# WARRANTY BULLETIN

Wb99-01

SUBJECT: CONDENSER FAN INSTALLATION

Model	VIN	
XL-45 Coaches Model Year : 1995 - 1999	From 2P9L3	3490 <u>S</u> 100 <u>1497</u> up to 2PCL33498 <u>V</u> 102 <u>6274</u> incl. except 2PCL33494 <u>V</u> 102 <u>6238</u>

Figure 2: Condenser compartment door. Section to remove.

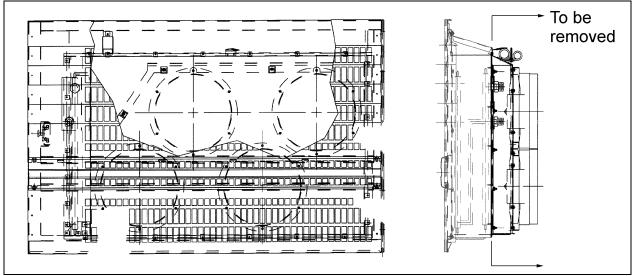
- 5. Temporarily remove the receiver tank from the vehicle. Discard the hose connecting the receiver tank and the door of the condenser compartment.
- 6. Disconnect the battery terminals, the Electronic Control Module (ECM) of the motor, the Electronic Control Units of the transmission and the ABS brakes, if applicable.
- 7. Remove the section of the condenser compartment containing the four fan motors (figure 2).

Figure 3: Finned floor to remove. (1) Angular brackets to cut.

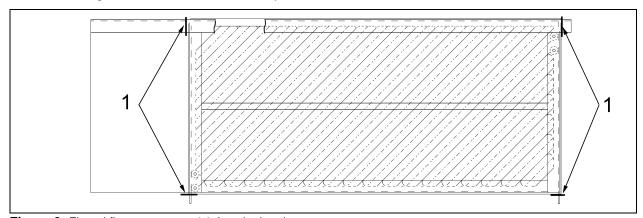
- 8. Cut the wire harness coming out of the A/C junction box (the wires are SP62, SP63, 57, 45E and 45A). Disconnect the three ground wires (OA, OB and O). Remove the A/C junction box.
- 9. Lift vehicle according to the Maintenance Manual, section 18, paragraph 28,2.
- 10. Remove the finned floor of the condenser compartment (figure 3). Using a circular saw cut the welding and the angular brackets located on every corner.

Figure 4: Top view of support assembly.

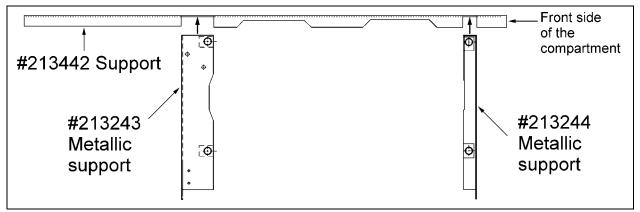
- 11. Temporarily install #213442 support (figure 4) underneath the vehicle. This support should lie against the front wall of the condenser compartment. Cut the length excess of the support's rear end. The support might interfere with the compartment floor. Use the support as a template to cut the extra metal of the floor.
- 12. Remove #213442 support and cut the extra metal.

- 15. Install #213243 support underneath the vehicle. This support fits together with #233442 as shown on figure 4. Weld.
- 16. Install #213244 support underneath the vehicle. This support fits together with #233442 as shown on figure 4. Weld.

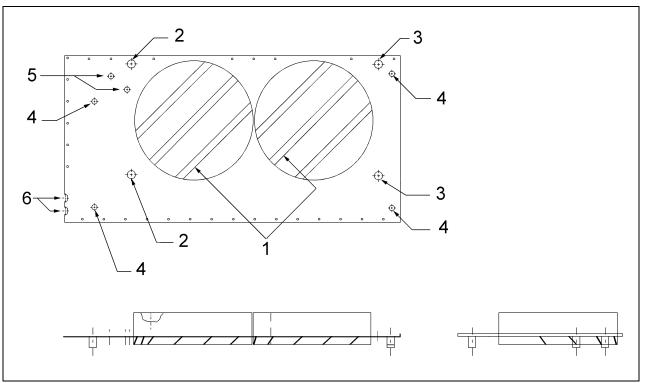
- 17. Clean the perimeter of the floor opening using Sika 205 then install #213948 bottom panel (figure 6) over. Ensure the holes of the panel fit with the holes of the welded supports underneath (#213442, #213243 and #213244).

- 19. Install #220977 support (figure 5) underneath the vehicle. Ensure the support holes are lined up with the bottom panel ones' (figure 6, item 6). Weld.

- 20. Apply Sika 221 all around the welded supports and the bottom panel.
- 21. Fasten the four #590284 evacuation hoses in the openings under the bottom panel (figure 6, item 4) using #504021 hose clamps.
- 22. Install #510342 shock absorber caps above holes 2 and 3 of figure 6. Add #500446 washers and install #452898 fan support (figure 7) above them. Secure using #502617 hardware.
- 23. Install both fans on motors using #452069 keys. As shown on figure 9, a 1.1 in (28 mm) gap must separate the motor from the fan.
- 24. Install the fan-motor assemblies in their cylindrical housings (figure 6, item 1) then fasten the motors to their vertical bases (figure 7, item 1). If necessary, use #283482 spacers with their washers, screws and nuts (#500441, #502528, #502744) to align the fans in their housings.

**Figure 9:** Interior of the condenser compartment, after the modifications. **(1)** Receiver tank; **(2)** #504025 Retaining clips for filter dryer; **(3)** #402792 and #453066 Decals.

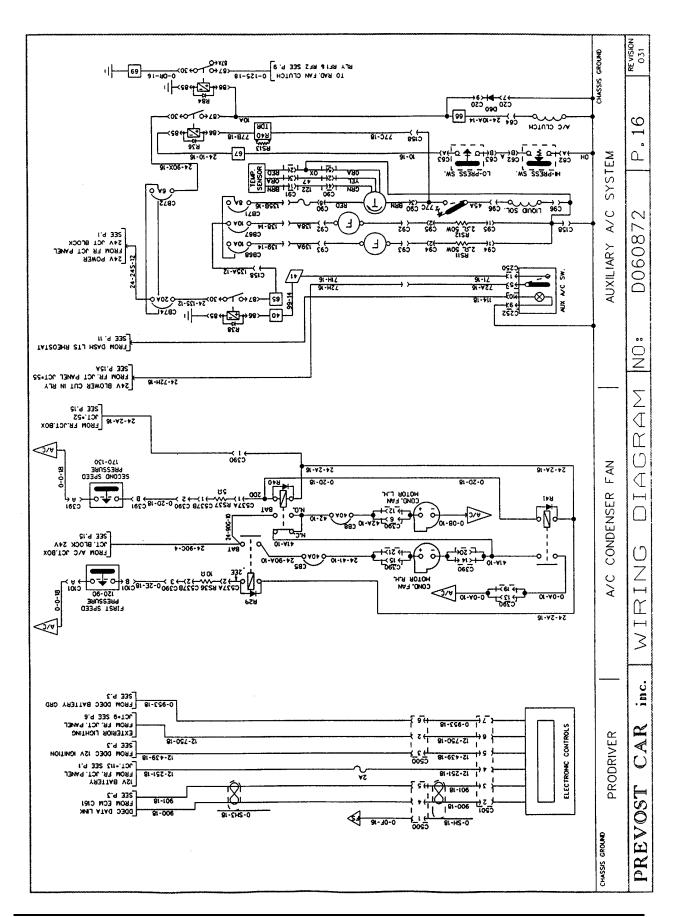
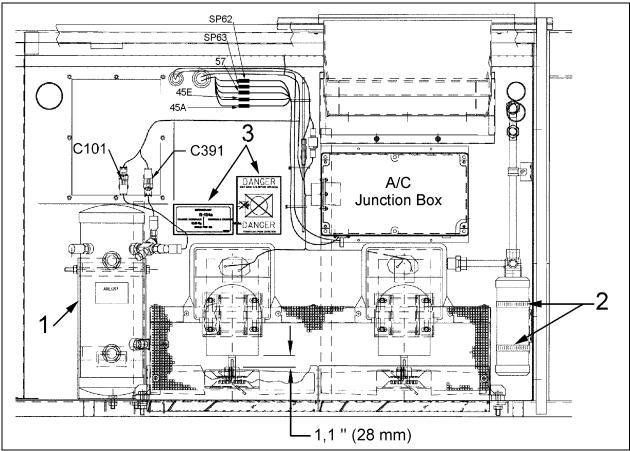
32. Remove 3 cm of sheath off the five wires cut in step 8. Remove also 3 cm of sheath off the five wires of the new A/C junction box. As shown on figure 9, twist wires together and weld (the wires are SP62, SP63, 57, 45E and 45A). Cover the connection with a heat shrink tube then heat. Plug the three ground wires (OA, OB and O).

- 33. As shown on figure 9, plug the C101 and C391 connectors of the receiver tank to those of the A/C junction box.
- 34. Connect the motor terminals.
- 35. Install #452011 plastic protectors over the motors using hardware #502568 and #500468, then install #452929 wire netting protector above the assembly, with #5001137 and #500641 parts.
- 36. Stick #453066 and #402792 decals as shown on figure 9, item 3.
- 37. Refill and check the A/C system according to your Maintenance Manual, section 22 (Charging System).
